Access Compliance Report Public Rights-of-Way (Curb Ramps)

Main Street: SHELTERWOOD_RD		Cross Street: RANCHWOOD_RD		Location:	NW
ADA ID: RPAT211013103250	Ramp Type: Type 4 - Parallel	Initial Pass/Fail: Pass	Overall Compliance: No	Severity Score:	0
Codes/Mitigation Info/Possible Solution			Field Measurements/Component Compliance

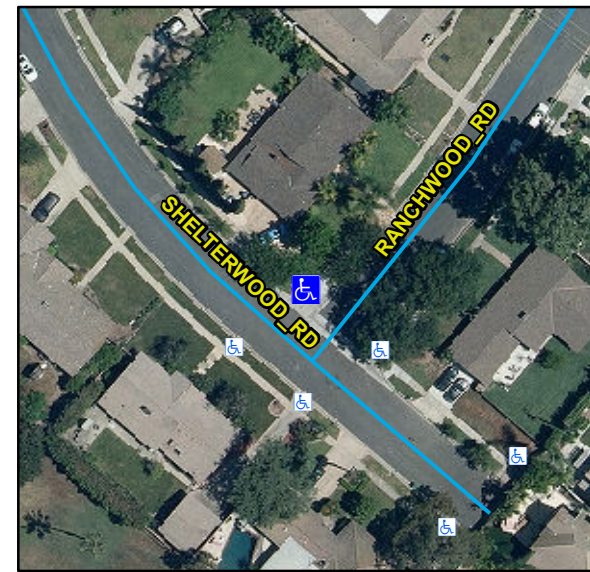
R304.2.2, R204.3, STD 1115

Remove & Replace Curb Ramp With Two New Directional Ramps or Equivalent.
